Bearing Carrier Nut Low Torque – 60 Bigfoot, 75 thru 125

Models Affected

a - Nut Torque 25 lb. ft. (33.9 N·m)

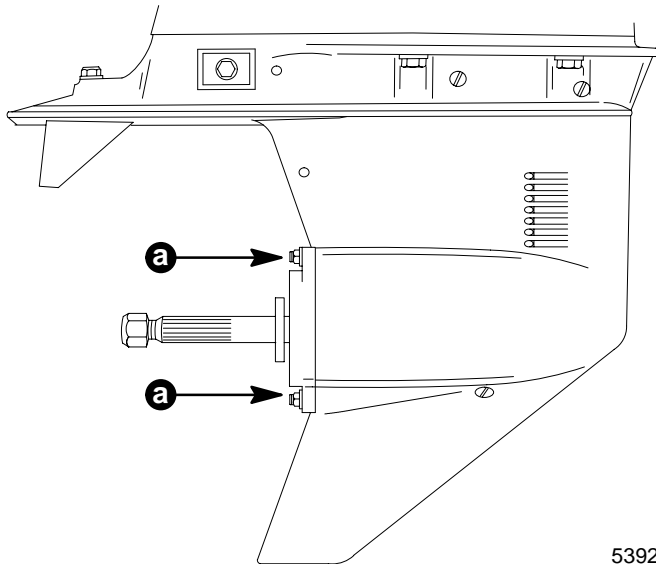
A small quantity of bearing carrier nuts on the models listed were torqued below specification during assembly. On these models, the bearing carrier may become loose and eventually fail the gearcase. It is necessary to retorque the bearing carrier nuts to the specified torque of 25 lb. ft. (33.9 N·m).

Loosen each bearing carrier nut, one quarter turn, and retorque to 25 lb. ft. (33.9 N·m). Paint the end of the stud/nut white for repair identification.
